**IMPERIAL METALS CORPORATION  
MT. POLLEY PROJECT**

**RESPONSE TO REVIEW COMMENTS  
ON TAILINGS EMBANKMENT DESIGN  
(REF. NO. 1625/6)**

**JANUARY 25, 1996**

**IMPERIAL METALS CORPORATION**  
**MT. POLLEY PROJECT**  
**TAILINGS STORAGE FACILITY**  
**STAGE Ib TAILINGS IMPOUNDMENT**  
**GENERAL ARRANGEMENT**

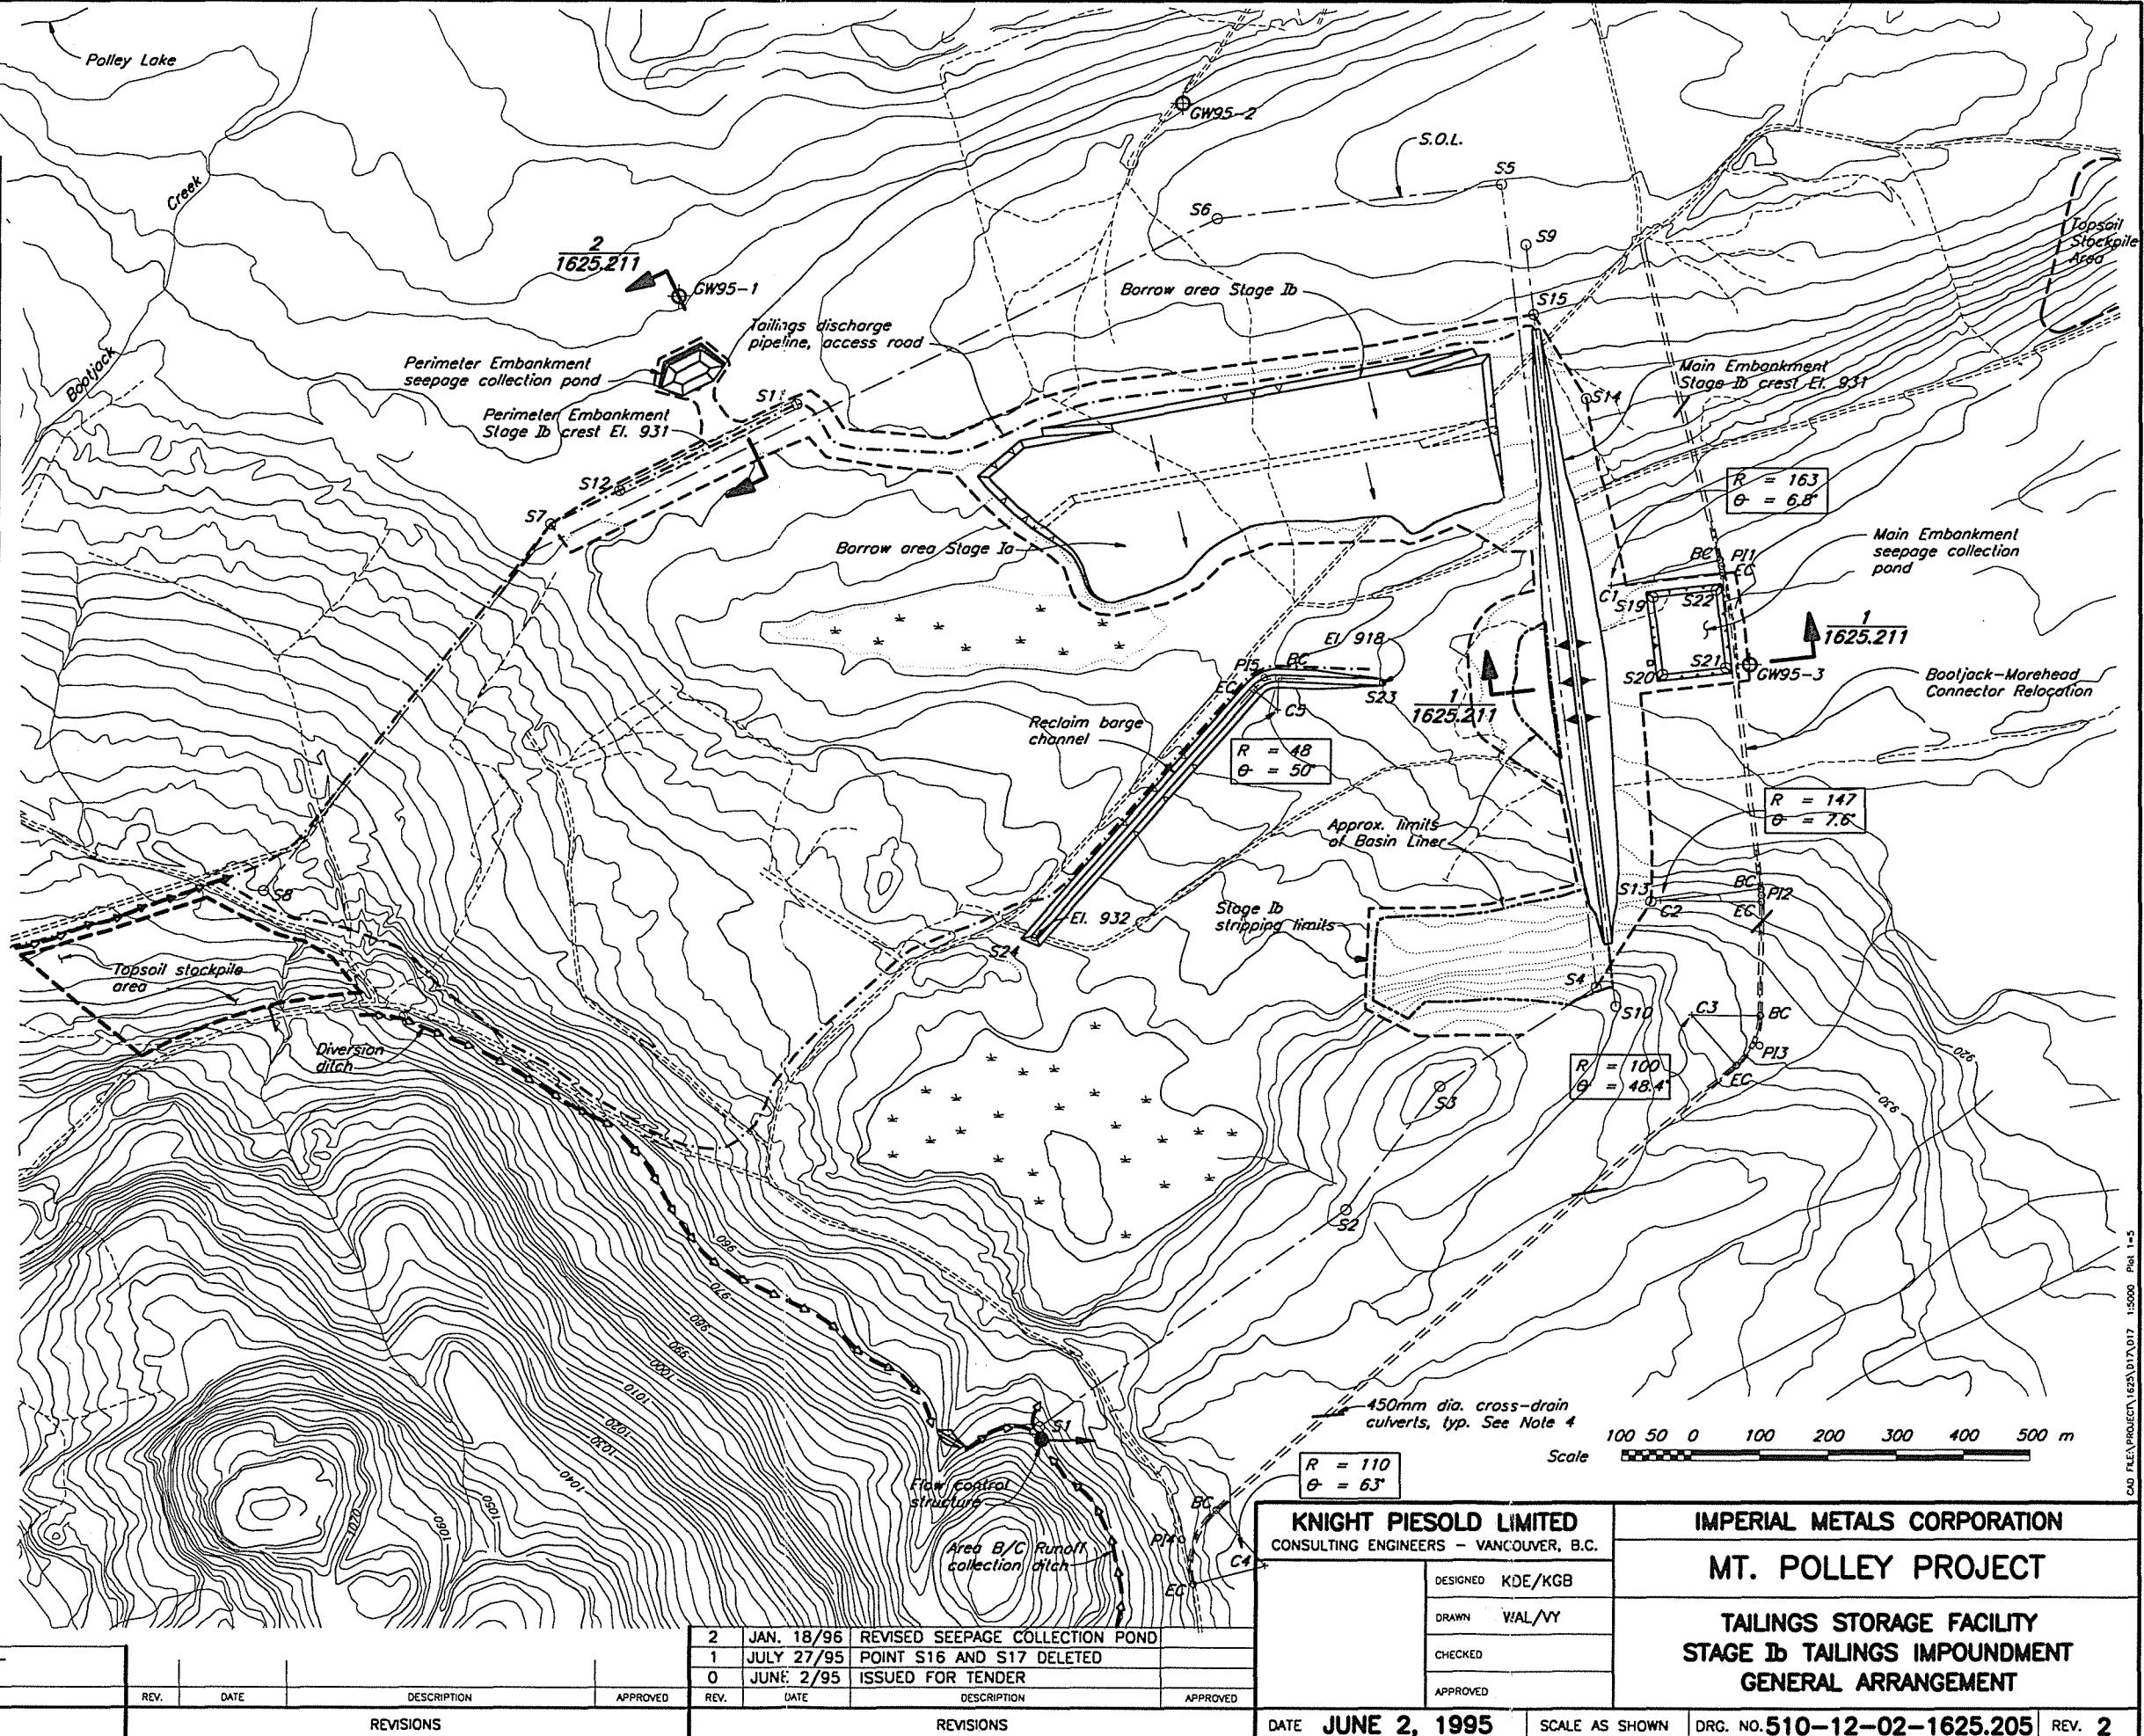
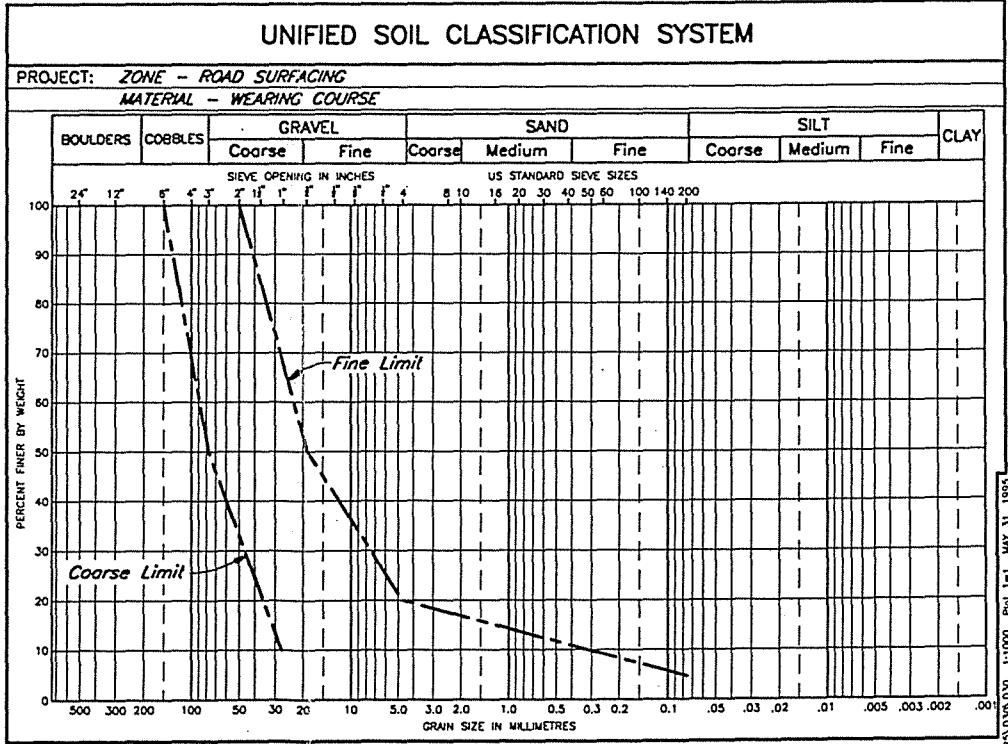
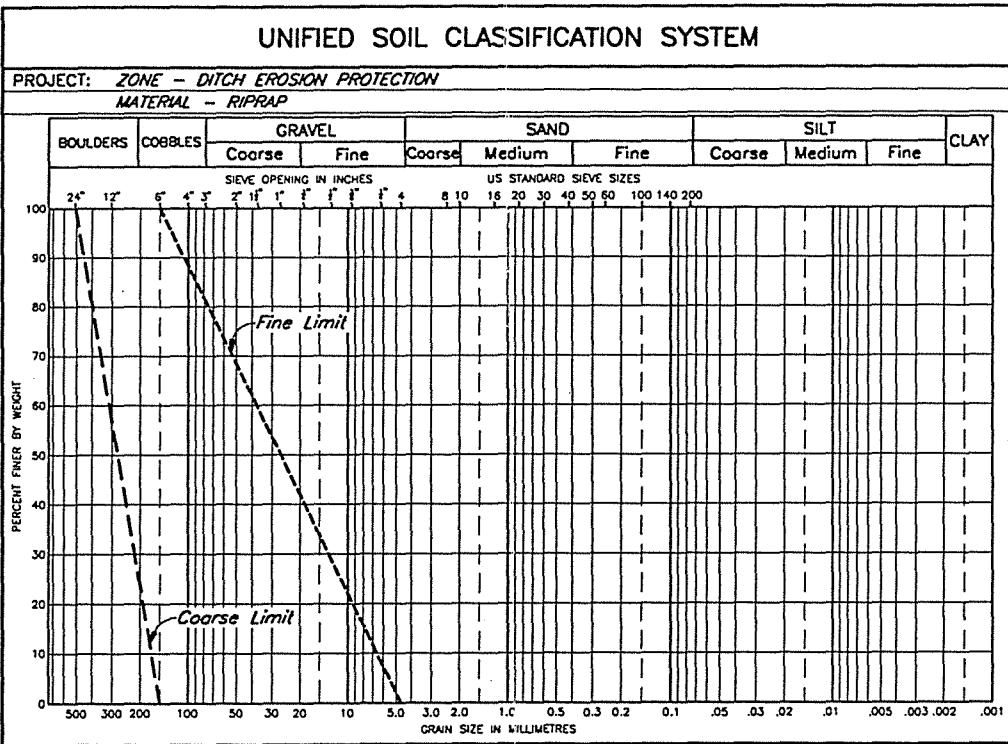
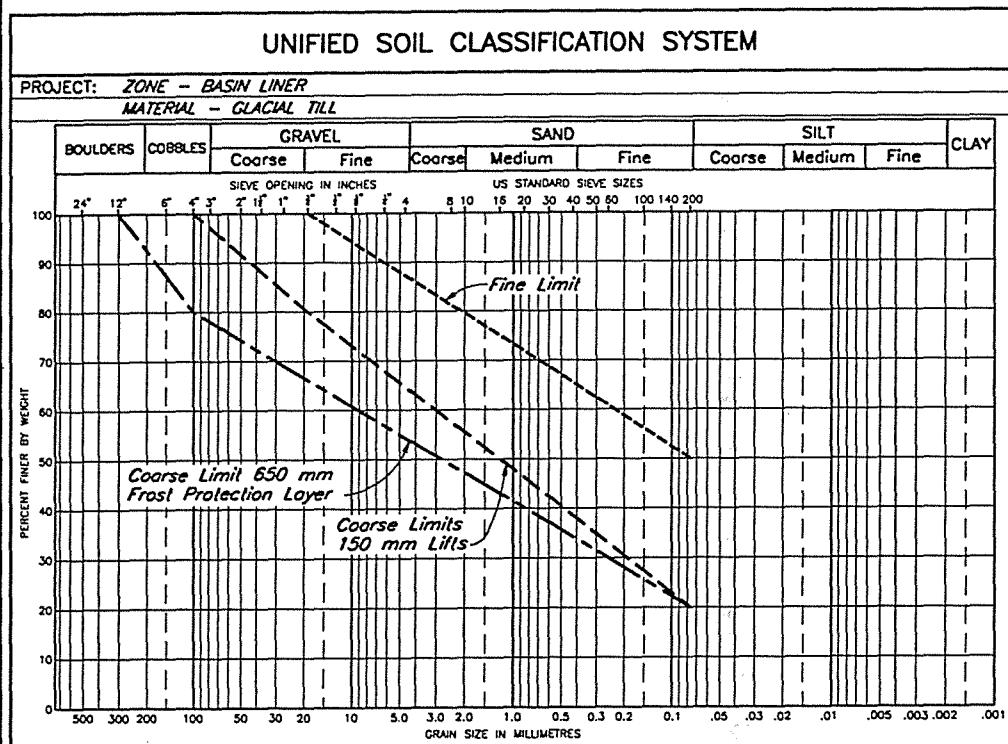
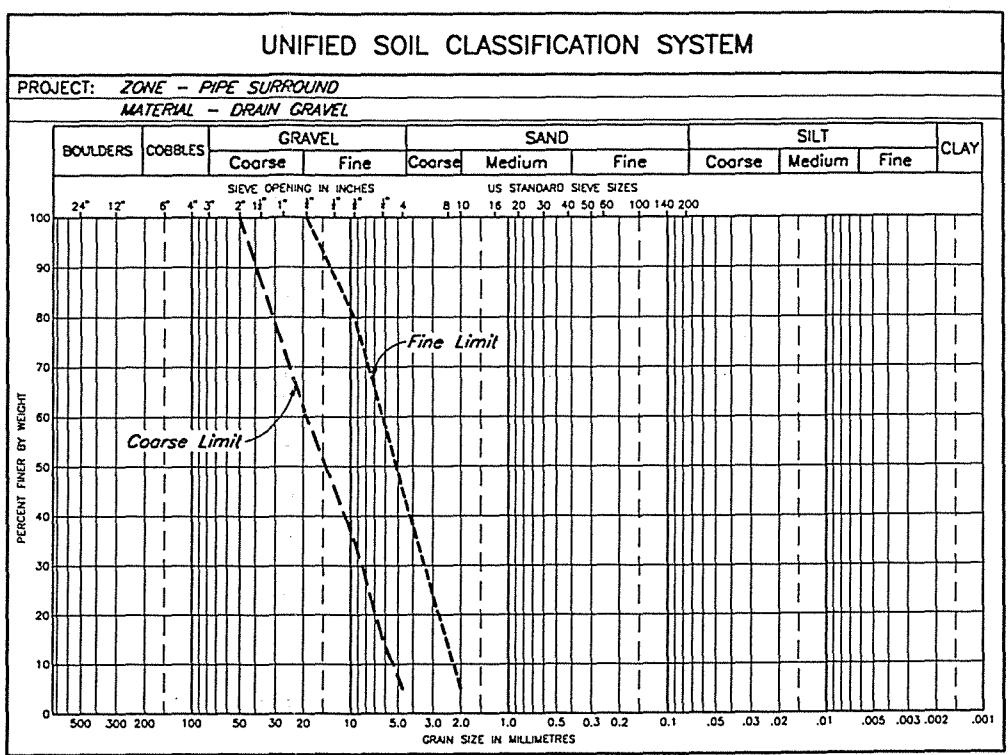
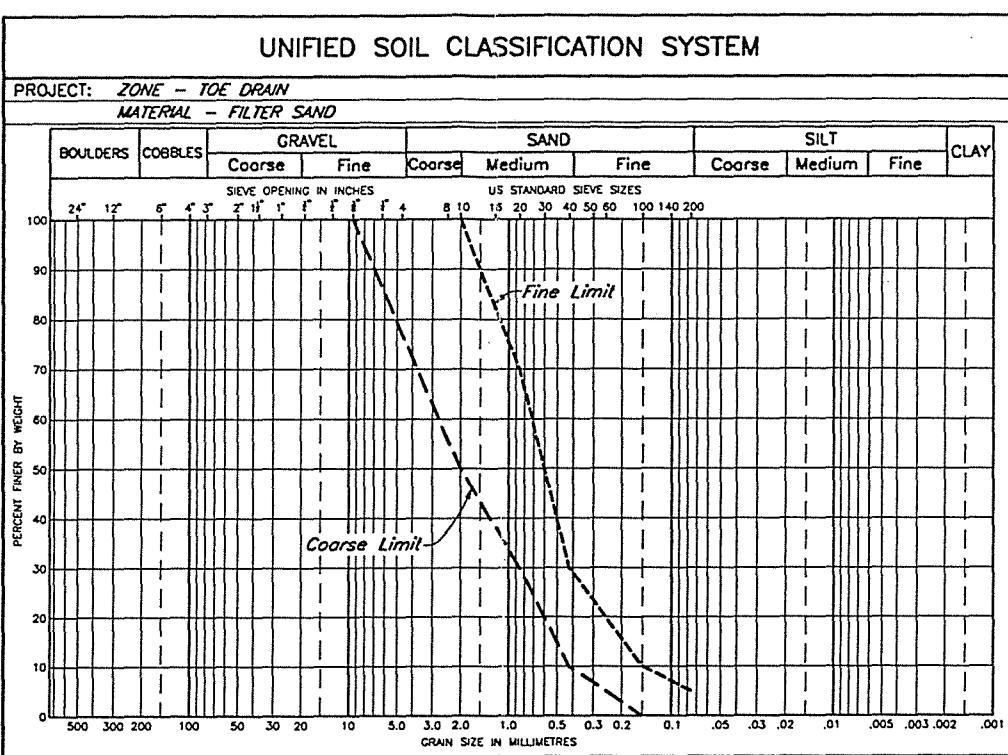
*Provide the location of these wells. Several must be downstream. List test requirements.*

Three permanent groundwater quality monitoring wells have been specified in the detailed design of the Tailings Storage Facility. The locations are shown on Drawing No. 510-12-02-1625.205. Additional monitoring wells will be installed as required during operations and as outlined in "Groundwater Monitoring Design Document" (Knight Piésold Ltd. Ref. No. 1625/5, May 19, 1995).

All monitoring wells will be installed in accordance with the industry standards and regulatory requirements, including proper well development and regular sampling and testing. The installation and monitoring requirements are also described in detail in "Groundwater Monitoring Design Document" (Knight Piésold Ltd. Ref. No. 1625/5, May 19, 1995).

IMPERIAL METALS CORPORATION MT. POLLEY PROJECT TAILINGS STORAGE FACILITY MATERIAL SPECIFICATIONS	DATE	JUNE 2, 1995	SCALE AS SHOWN	DRG. NO.	510-14-03-1625.212	REV. 0

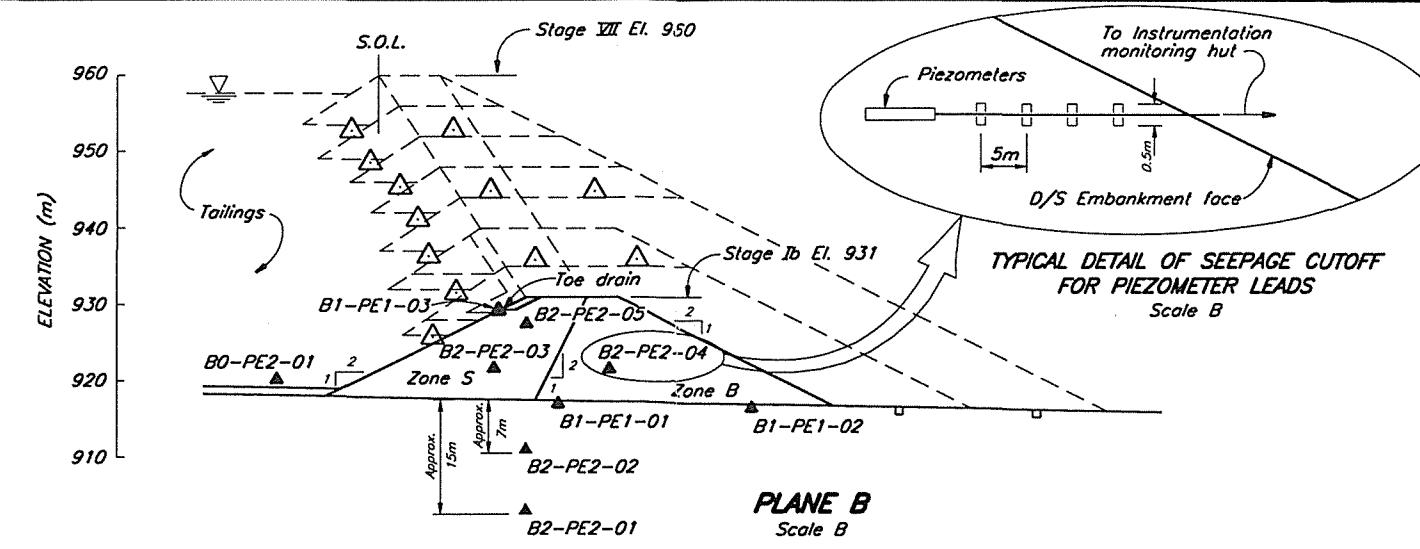
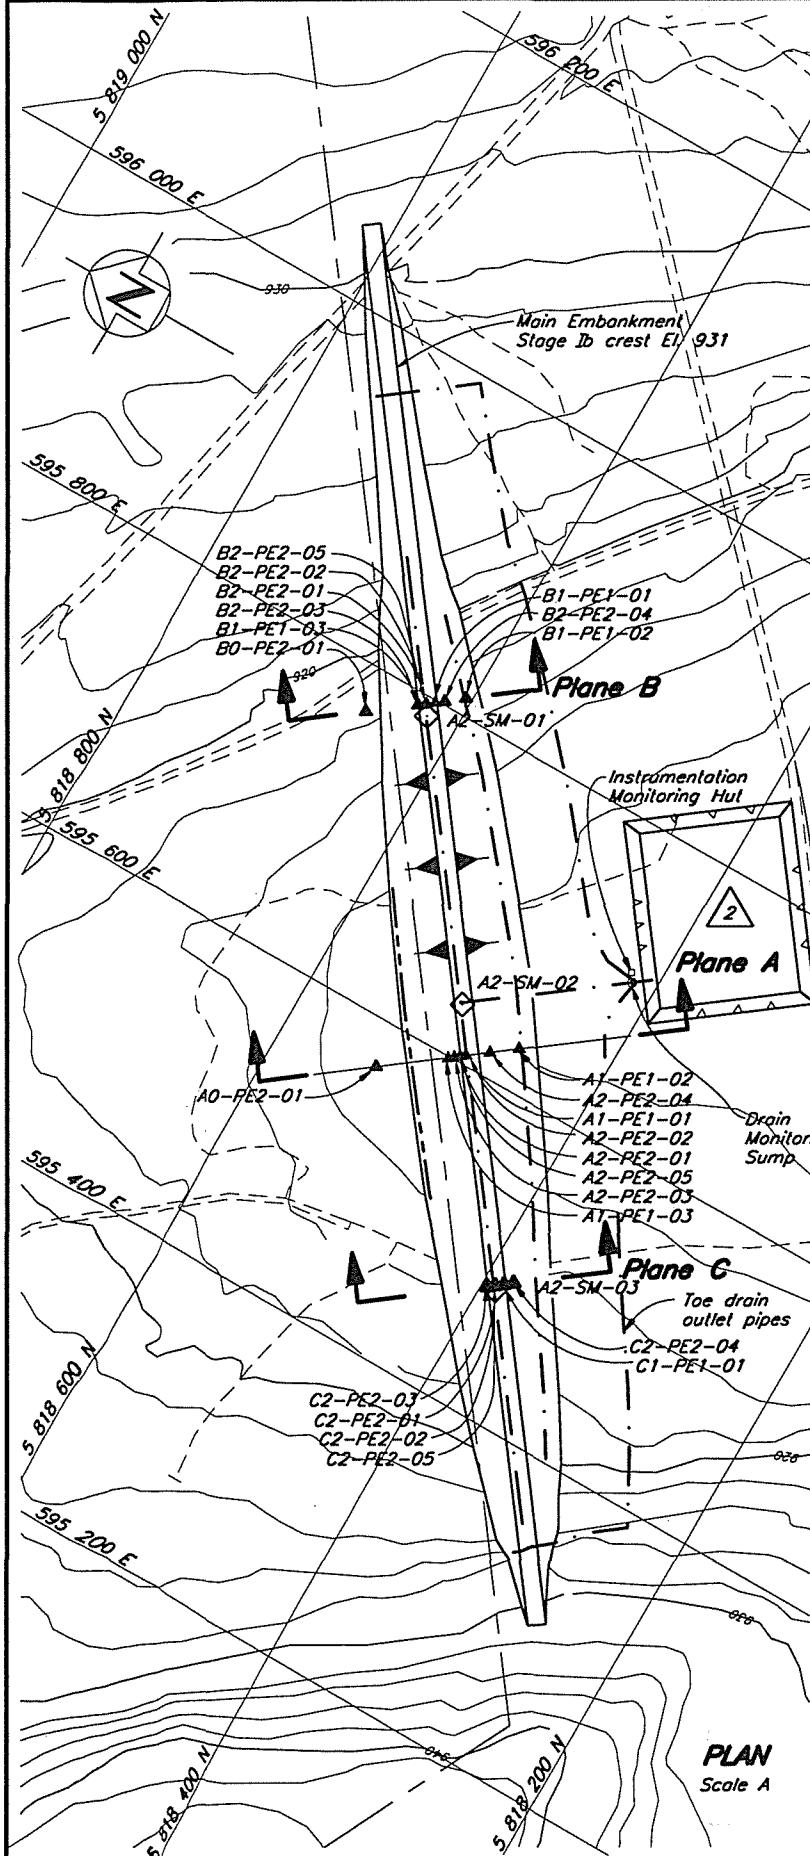
***Filter gradation is required to be shown. The design must be conservative.***

*Provide the range of acceptable gradation.*

Filter gradations for construction materials are shown on Drawing No. 510-14-03-1625.212, which is taken from part of the Technical Specifications. The gradation of the tailings is shown on Figure 1 (from Tailings Storage Facility Design Report, Ref. No. 1625/1, May 26, 1995).

Gradation envelopes for embankment fill materials are also included on Drawing No. 510-14-03-1625.212.
